BRIGHT LORITOS NOVI OUTDOOR PLAY AREA JSP23-28

PLANNING REVIEW

Bright Loritos Outdoor Play Area

JSP 23-28

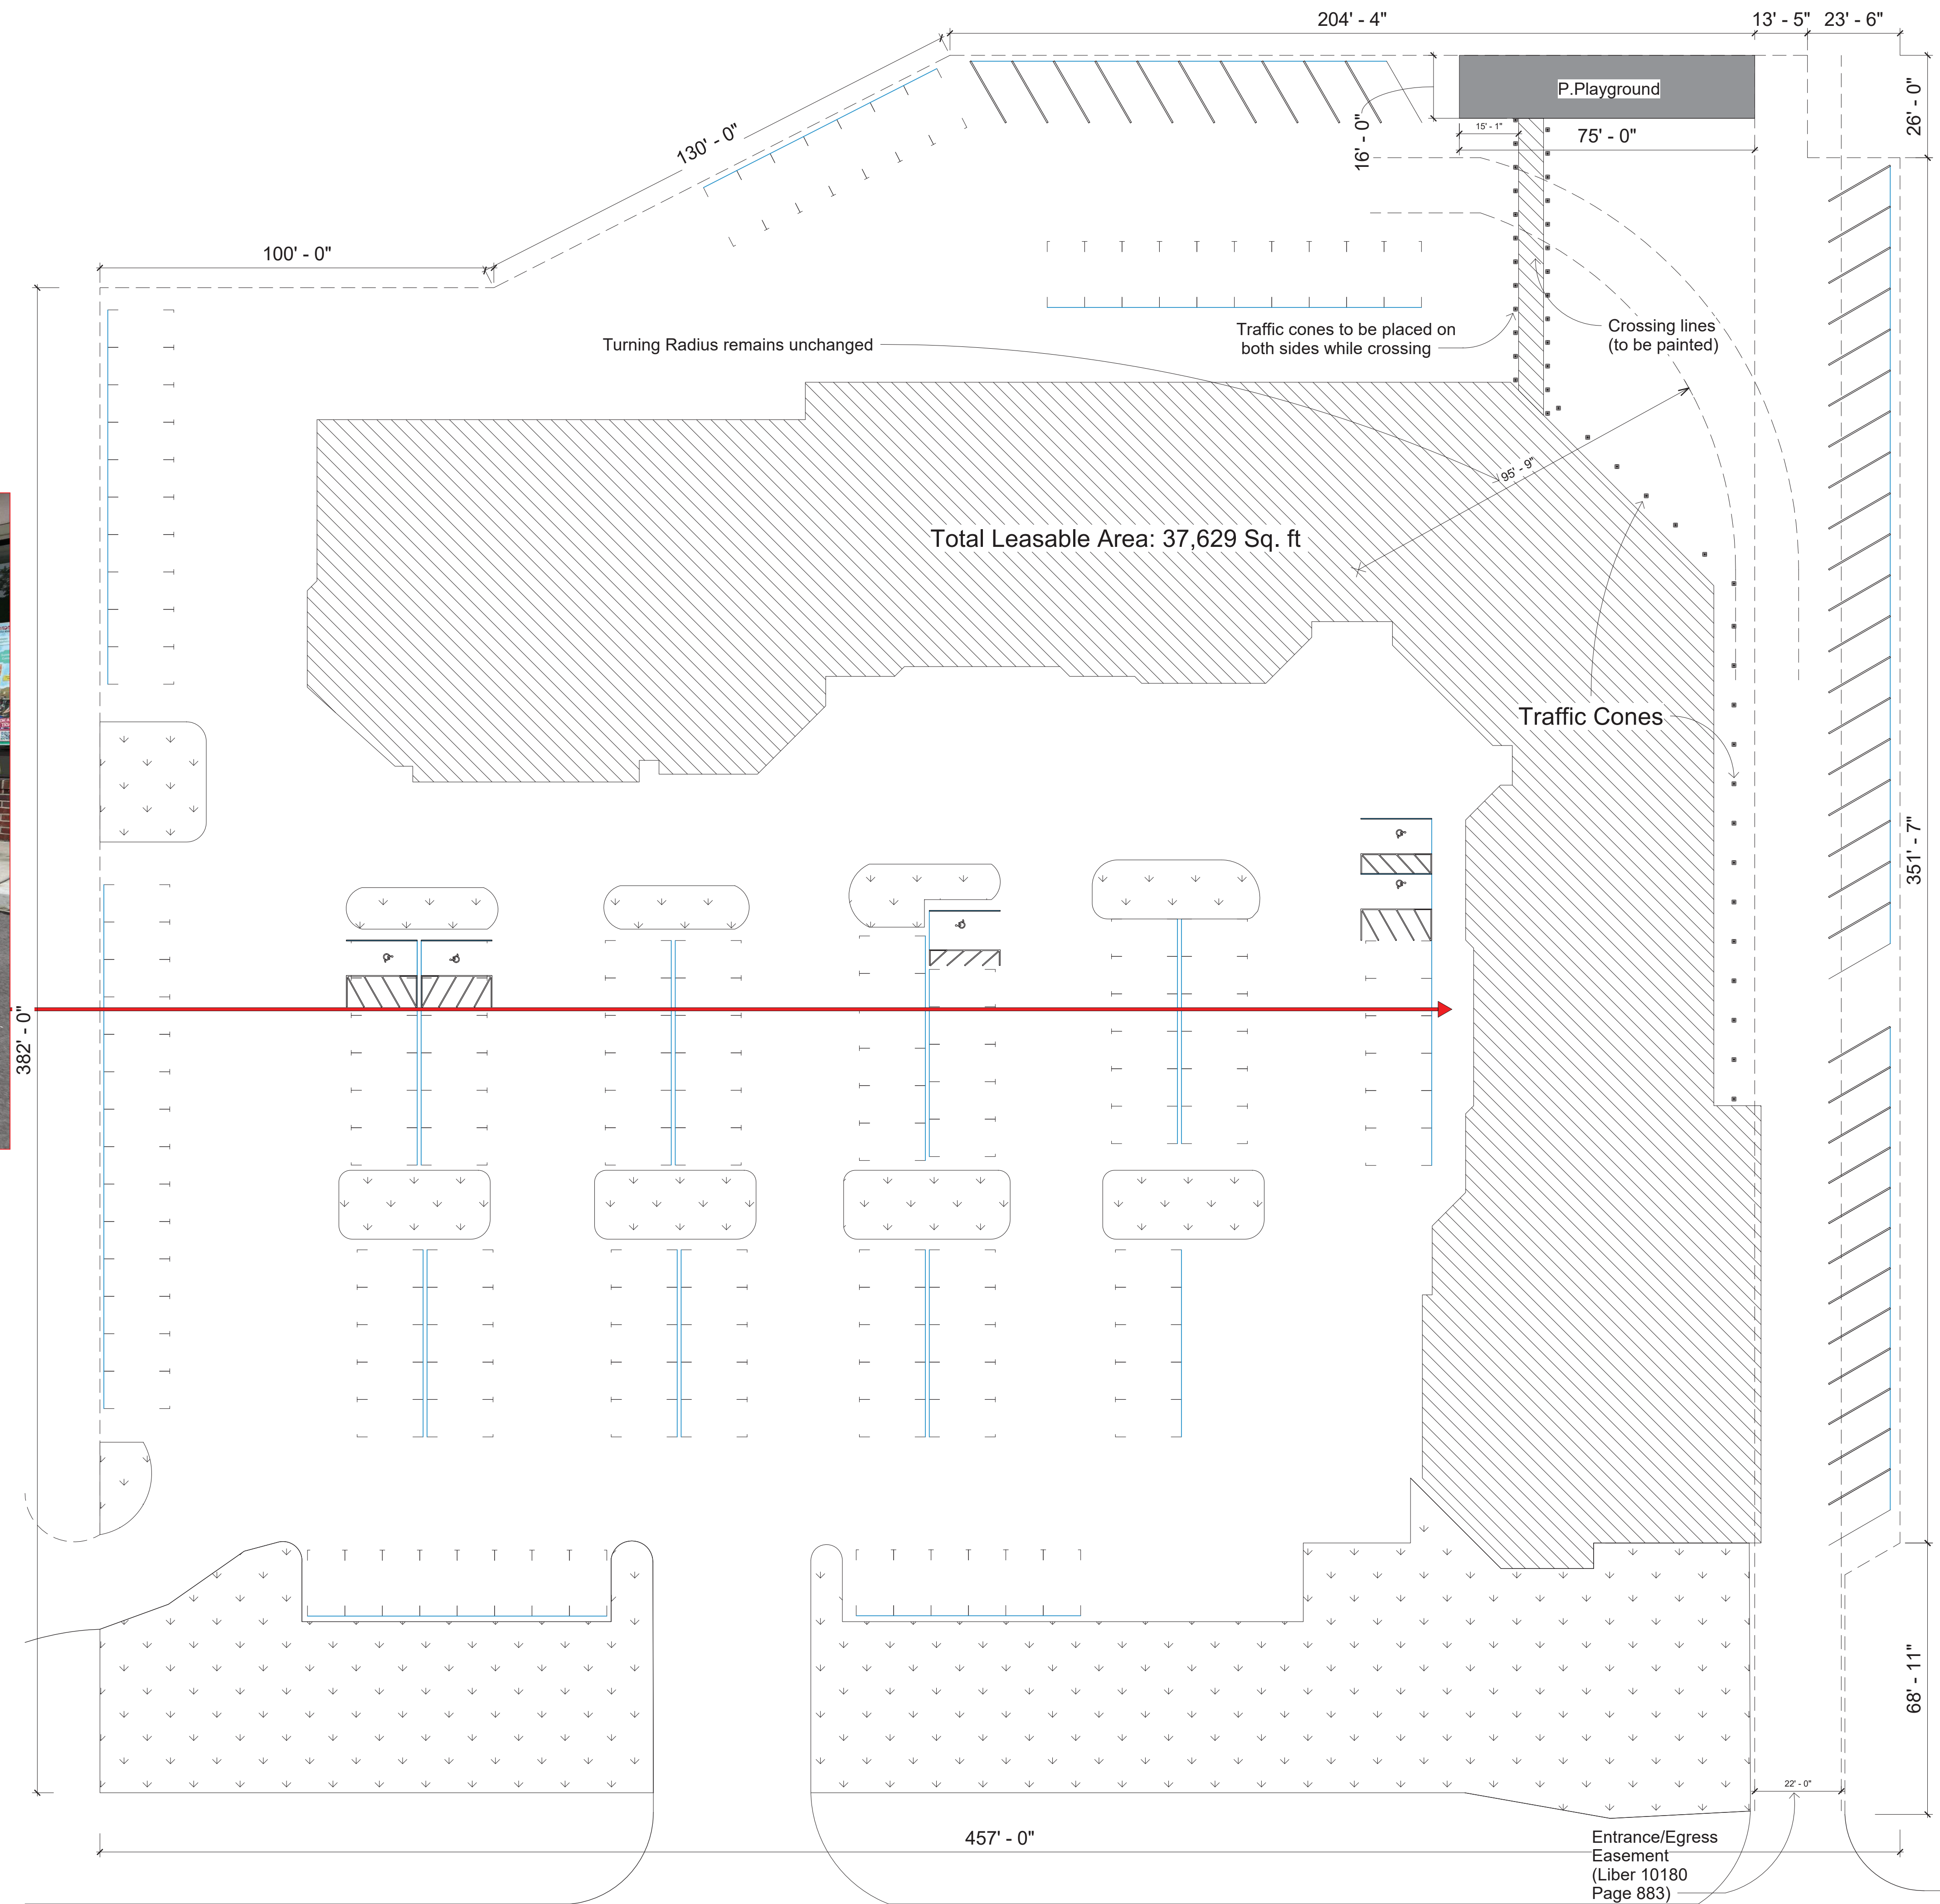
2. Day Care Center outdoor recreation screening requirement (Sec. 4.12.2.i.d): Screening shall comply with Section 5.5. *The City would prefer that the fencing be of a material and likeness similar to that of the play area shown in the site plans for Bright Loritos in Troy, Michigan.*

8. Number of Parking Spaces (Sec.5.2.12.C): 1 space per 250 square feet of Gross Leasable Area (GLA); 37,249 sq ft GLA = 151 required spaces. *183 total spaces provided.* **Please indicate how many spaces are being removed for the play area.**

9. Parking Space Dimensions and Maneuvering Lanes (Sec. 5.3.2) **Provide dimensions of the walkway created for guiding the children to the play area from the building.**

8. Number of Parking Spaces (Sec.5.2.12.C): 1 space per 250 square feet of Gross Leasable Area (GLA); 37,249 sq ft GLA = 151 required spaces. 183 total spaces provided. **Eight (8) parking spaces are being removed to provide for playground. (See sheet 001)**

9. Parking Space Dimensions and Maneuvering Lanes (Sec. 5.3.2) **Walkway created for guiding the children to the play area from the building will be five feet wide by approximately 60 feet long (5' x 60'). (See sheet 001, 002)**

1 Playground
1 : 30

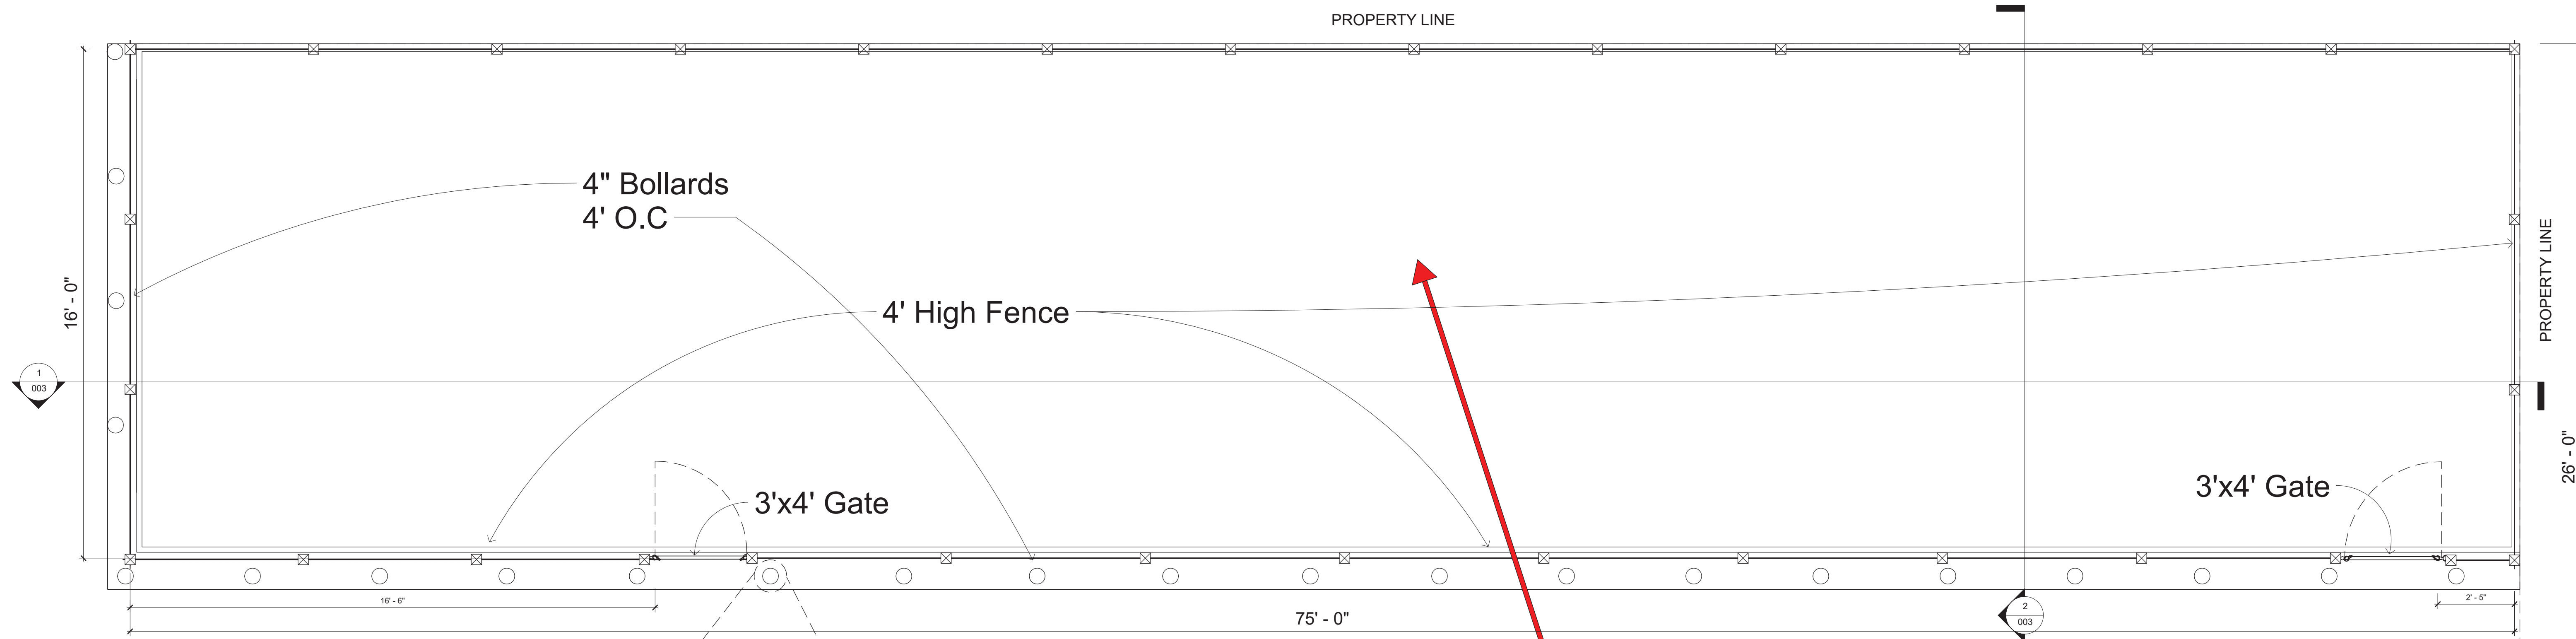
11. Bollards and self-closing gates: **Please provide the materials of the bollards and details concerning the 'local alarms' that are to be installed with the self-closing gates.**

11. Bollards and self-closing gates: **Bollards will be of 4" iron pipe filled with concrete, covered with a heavy vinyl sleeve. Self-closing gate:** https://www.amazon.com/Alarma-puerta-ventana-alarmas-seguridad/dp/B07PGXQYC9/ref=sr_1_1_sspa?__mk_es_US=%C3%85M%C3%85%C5%BD%C3%95%C3%91&crd=23GT4Y71CEORW&keywords=gate+alarm&qid=1691589234&srefix=gate+alarm%2Caps%2C117&sr=8-1-spons&sp_csd=d2lkZ2V0TmFtZT1zcF9hdGY&psc=1 **(See sheet 003)**

1 Section 1
1 : 30

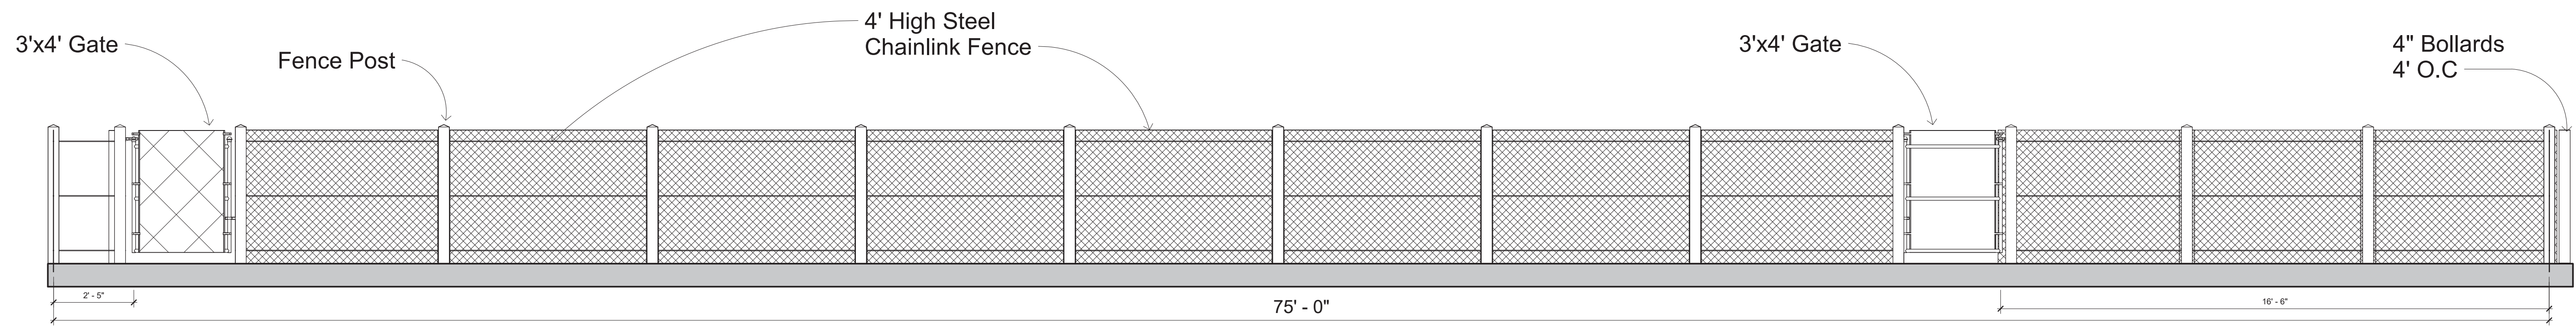
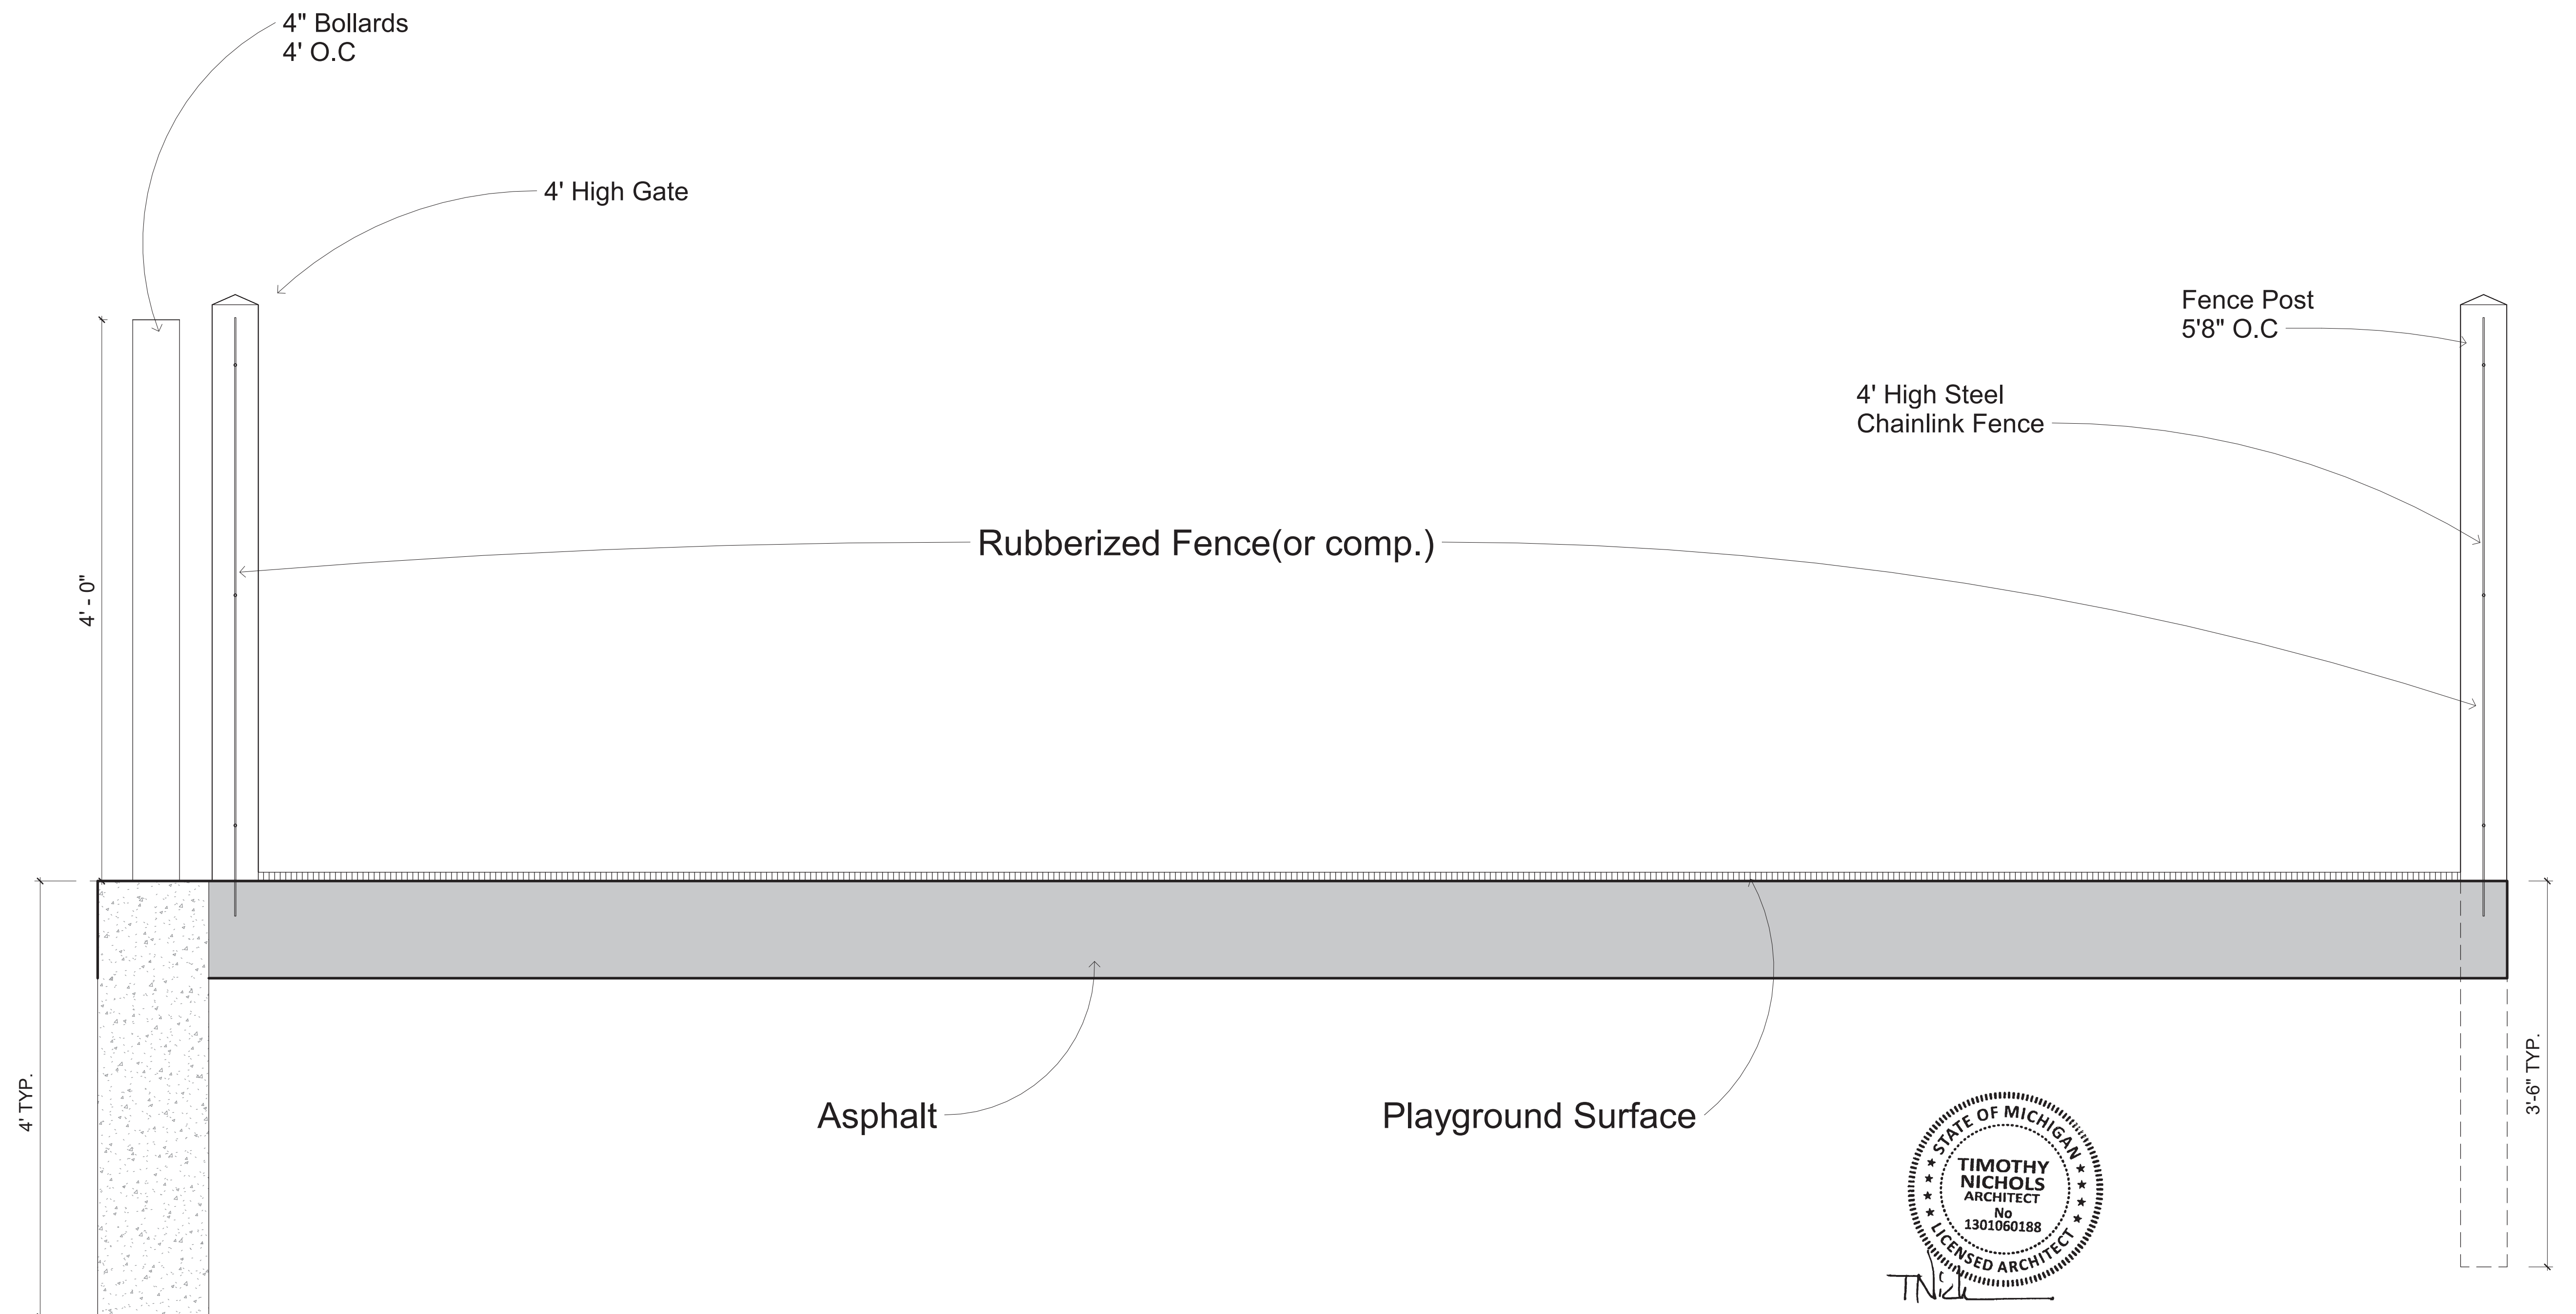
12. Fences (Sec. 5.11): **Please provide a note on the plans that the fencing will comply with applicable provisions of the current City of Novi Maintenance Code.**

2. Day Care Center outdoor recreation screening requirement (Sec. 4.12.2.i.d): **Screening shall comply with Section 5.5. The City would prefer that the fencing be of a material and likeness similar to that of the play area shown in the site plans for Bright Loritos in Troy/Rochester, Michigan. EZ Fence Asbury 4' 6" x 6' Black 3-Rail Aluminum Fence Panel (Actual Size 54" H x 69-3/8" W)**

12. Fences (Sec. 5.11): Please provide a note on the plans that the fencing will comply with applicable provisions of the current City of Novi Maintenance Code. **(See sheet 003)**
